Subject: #1 & 3 Harbor Drive: List of Changes

Please see the summary of changes made for the resubmitted drawings dated 8/24/20.

# HARBOR DRIVE EXECUTIVE OFFICE PARK

8/24/20 PLANNING RE-SUB 2

PROJECT SCOPE **WATER SAVING CALC**

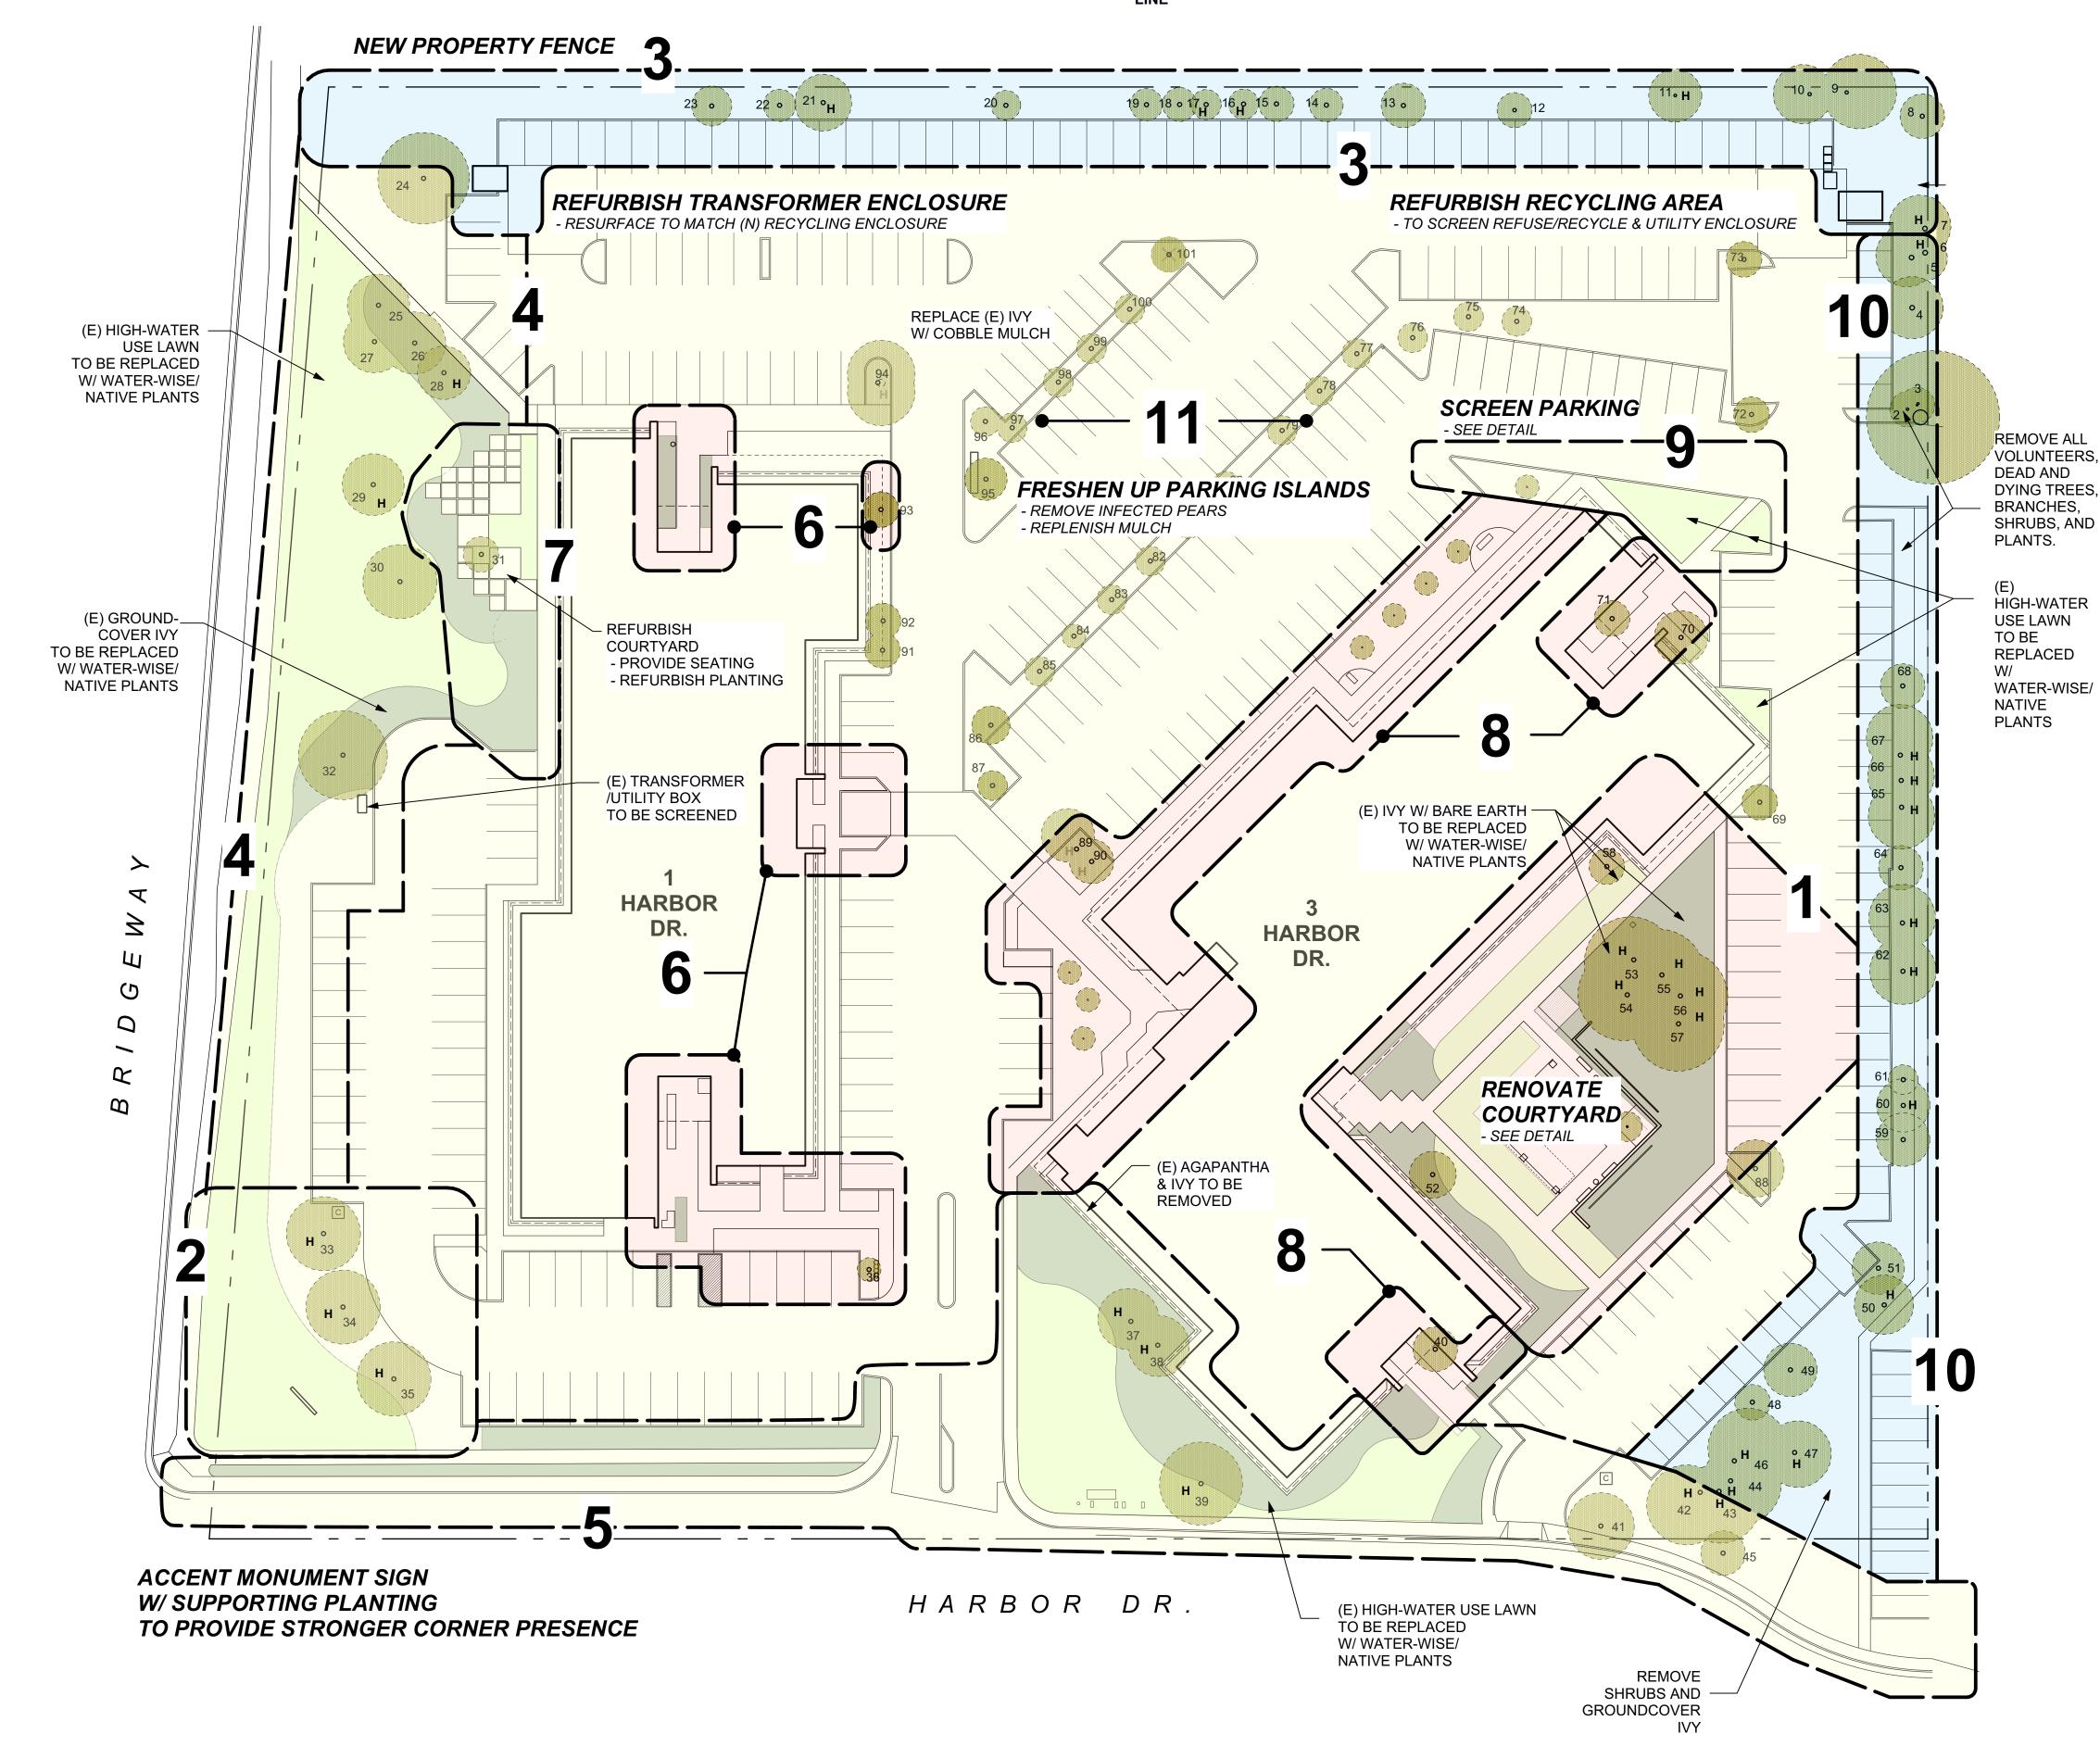
- 1. L-1 is divided into two sheets, L-1.1 (site improvement) and L-1.2 (tree inventory and removal).
- 2. On L-1.1, Per the request made during the Planning Commission meeting, a rough idea of the water savings by replacing the existing lawn irrigated with spray to the drip irrigated, water-wise/native plants is included. An example of the expected savings for a week in July with this replacement is shown.

(E) LAWN TO BE REPLACED W/ WATER-WISE/NATIVE PLANTS **IRRIGATION TO BE CONVERTED** TO DRIP SYSTEM: WATER WILL BE SAVED **APPROX. 13,191 GALLON PER WEEK IN JULY**

ETWU =  $4.65 \times 0.62 \times (1/0.75) \times 21800$ = 83,799 gallon per month

ETWU =  $4.65 \times 0.62 \times (0.4/0.81) \times 21800$ = 31,037 gallon per month

= approx. 13,191 gallon per week in July

(E) TREE PLAN & PHOTOS

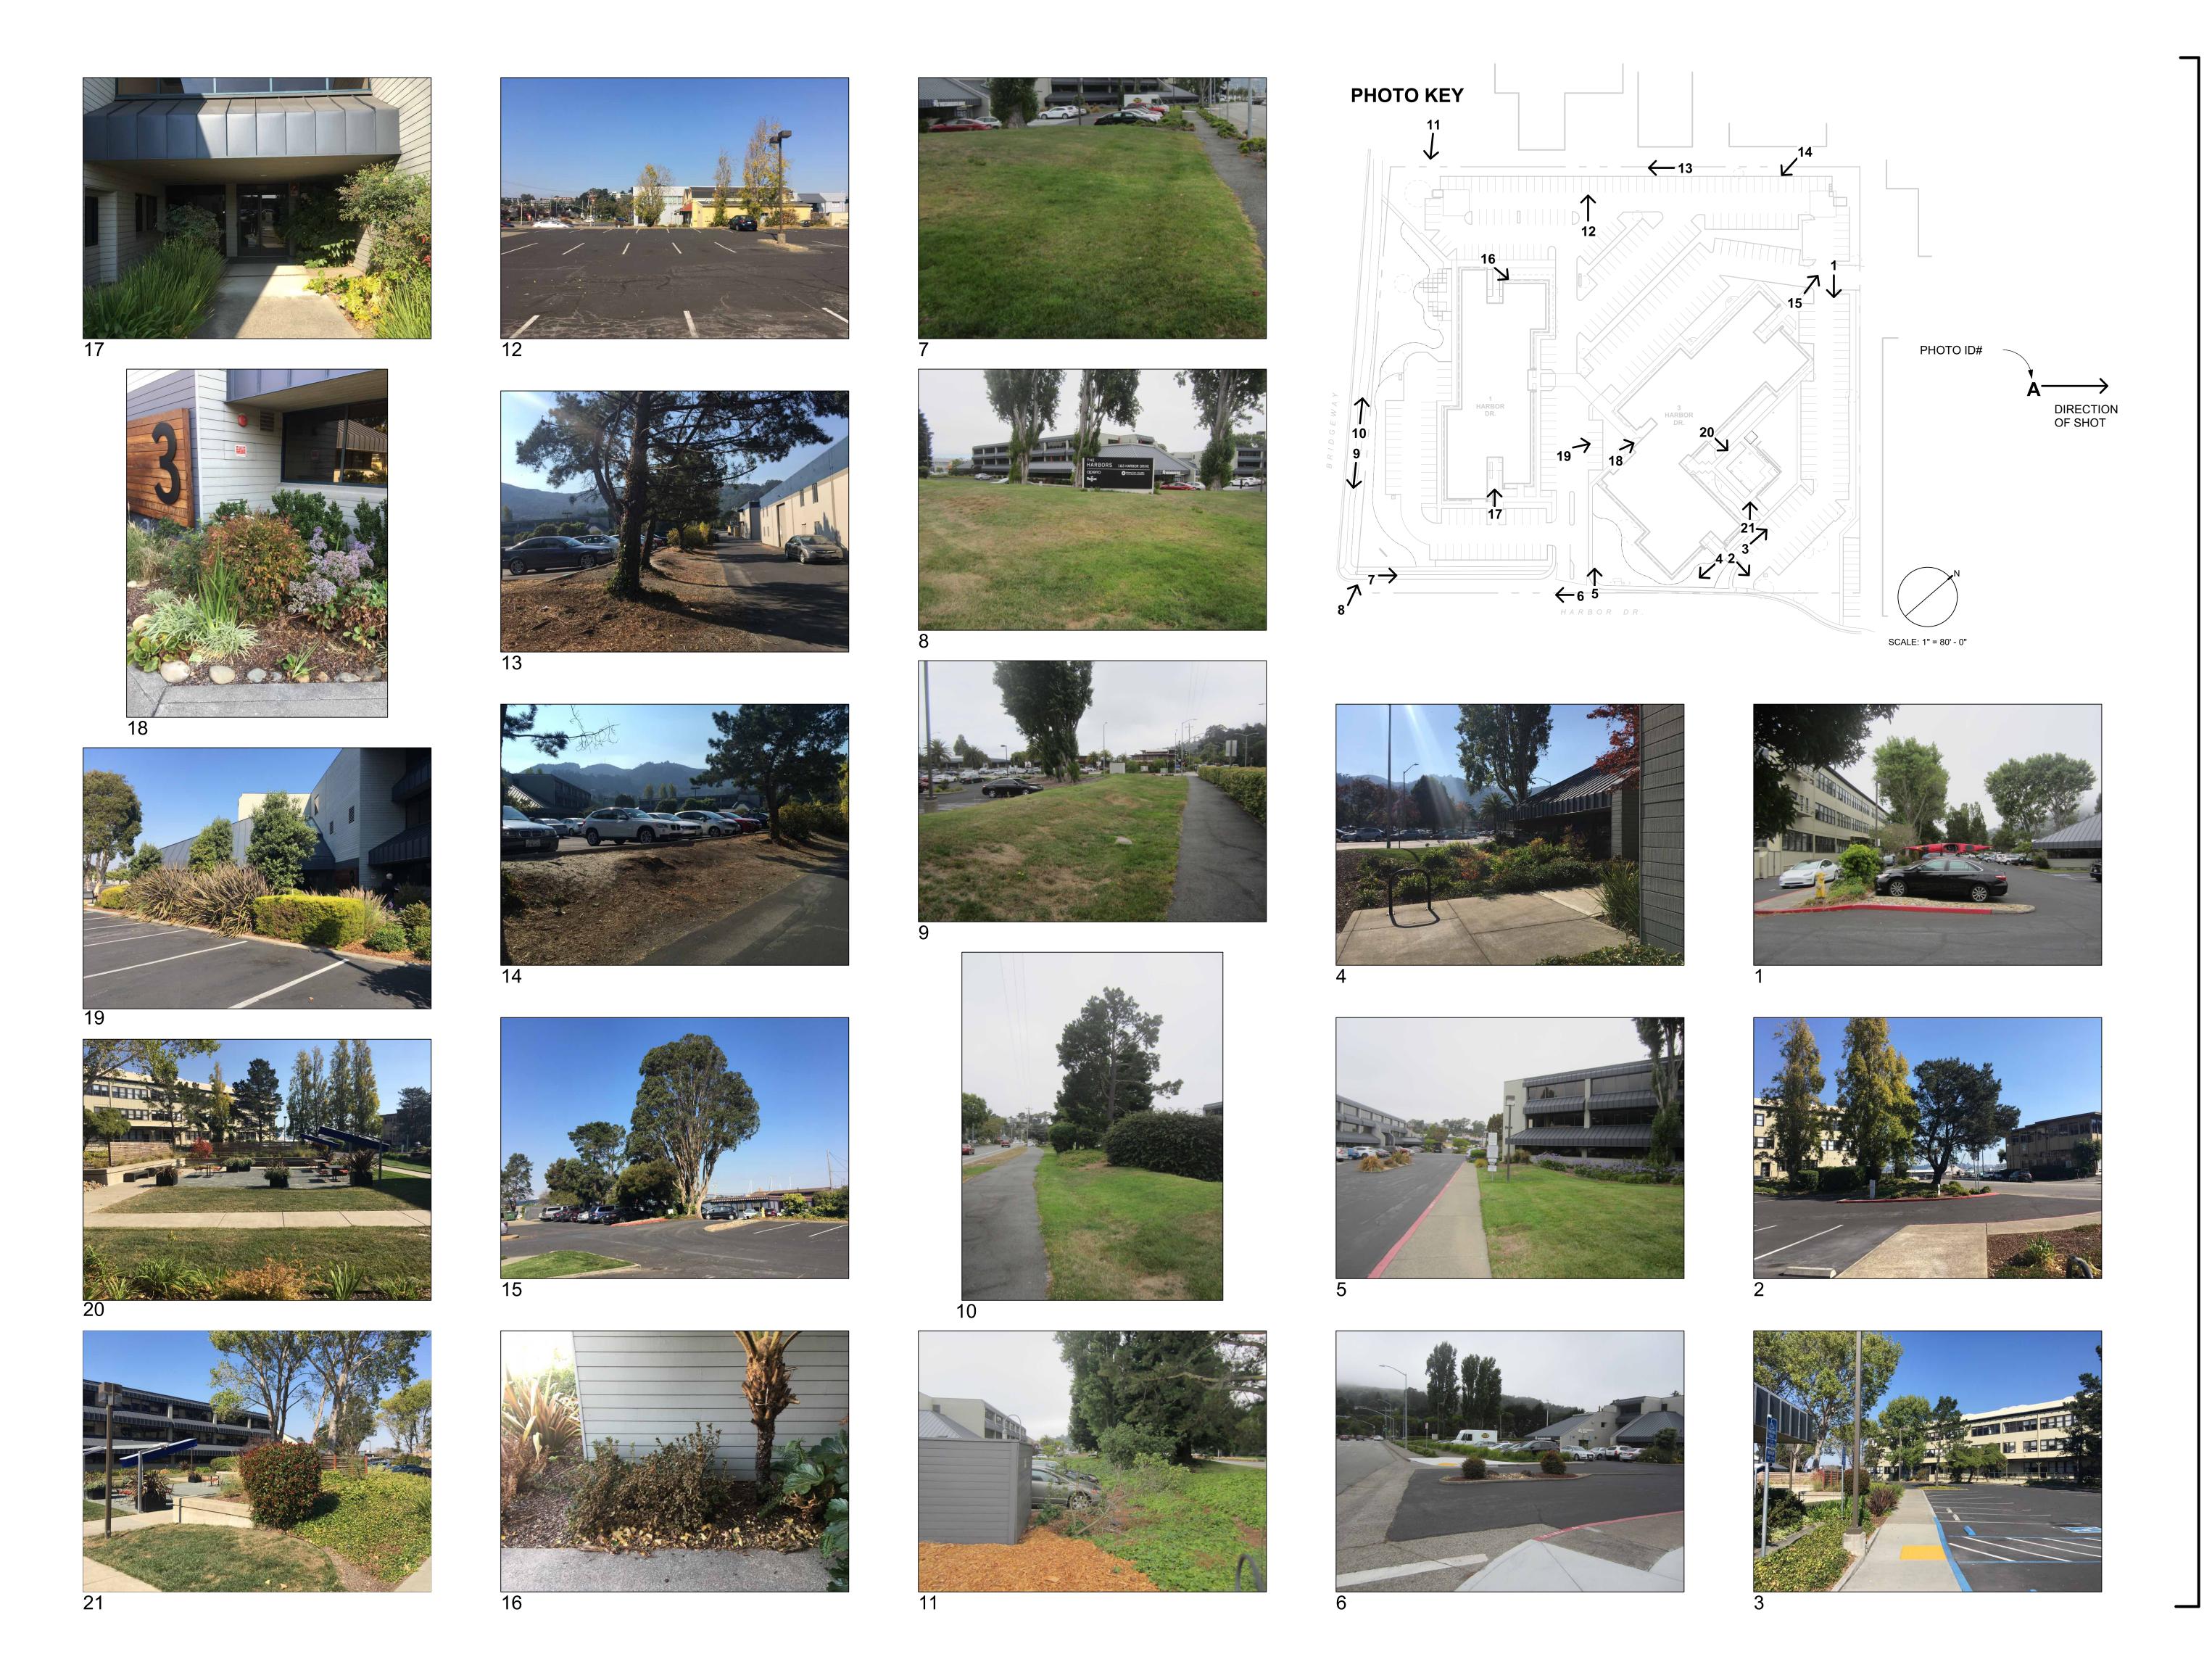
- 3. To address the concern of the commissioners and the neighbor's for the tree removal, we revisited the plan.
  - i. Only remove two large Lombardi Poplars, which are very close to Building 3 and are causing hardscape damage and potential hazards to the building and the occupants. One willow along Bridgeway is also proposed to be removed.

- ii. Instead of removing the remaining large poplars, we propose interplanting new trees (Eucalyptus or alternate, Ginkgos). As they grow they will replace the existing large trees in time.

- iii. Monterey Pines and Acacias to be removed (not protected and on the undesirable tree list in Sausalito).
  - iv. Leave other ornamental trees unless there is problem with their health, structure or form.

**MASTER PLAN**

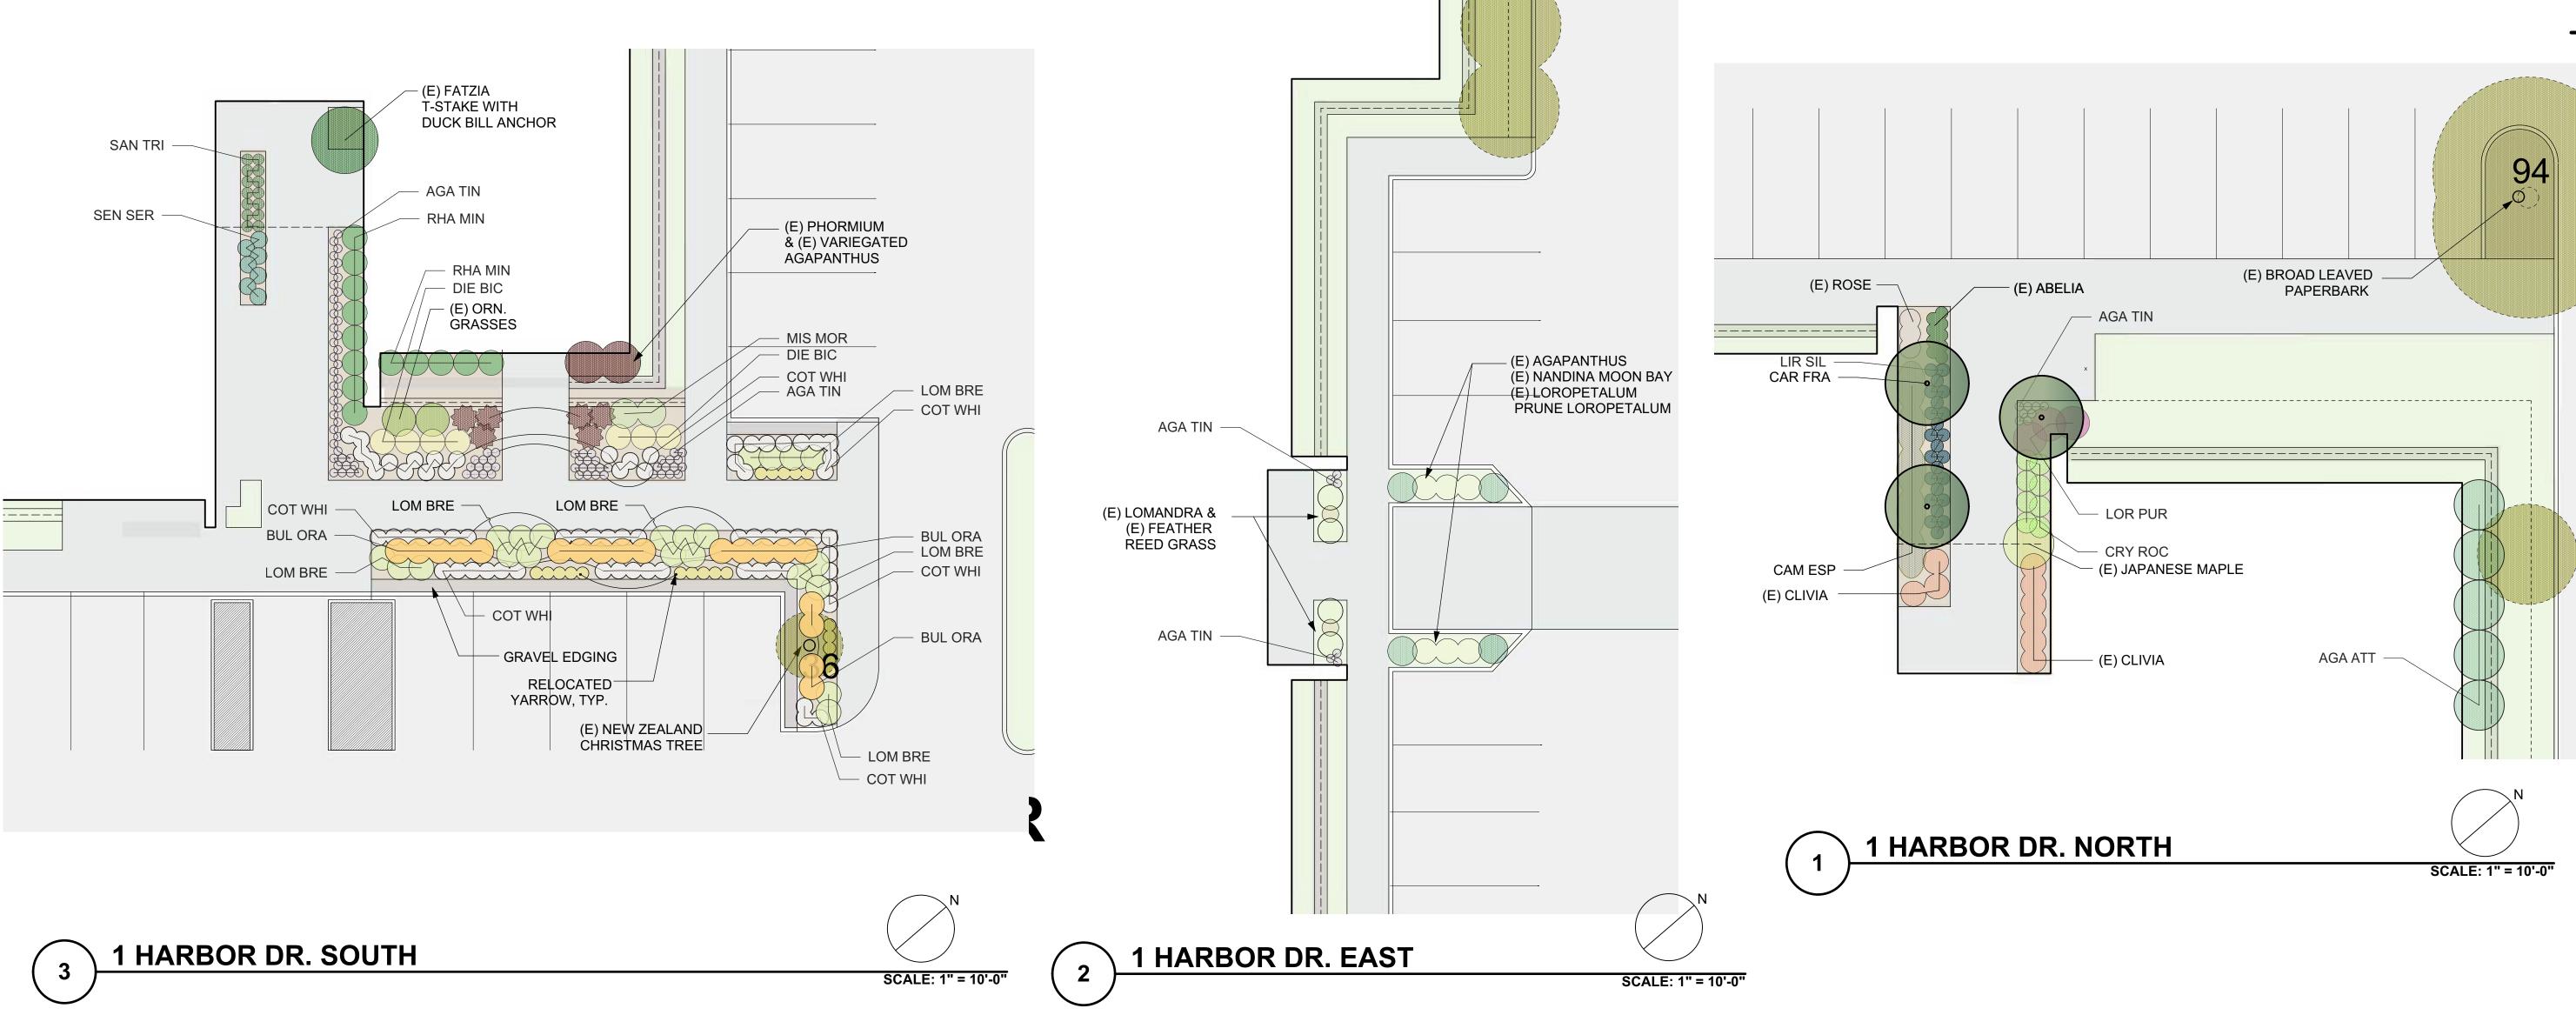
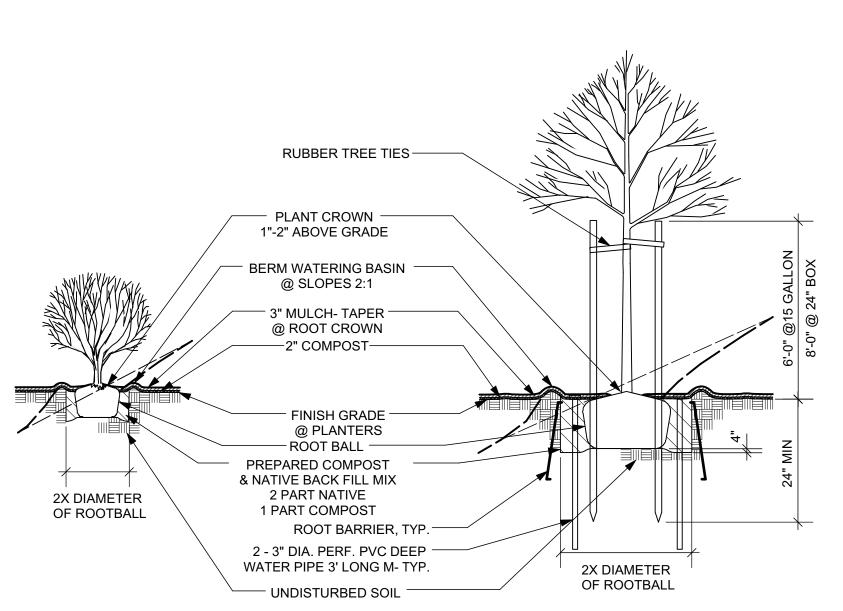
- 4. A row of street trees (Magnolia 'Little Gem' Dwarf Southern Magnolia) will be added along Bridgeway.
- 5. Asphalt along Harbor Drive is to remain.
- 6. Master Plan is updated to reflect items #3 to #5 above.
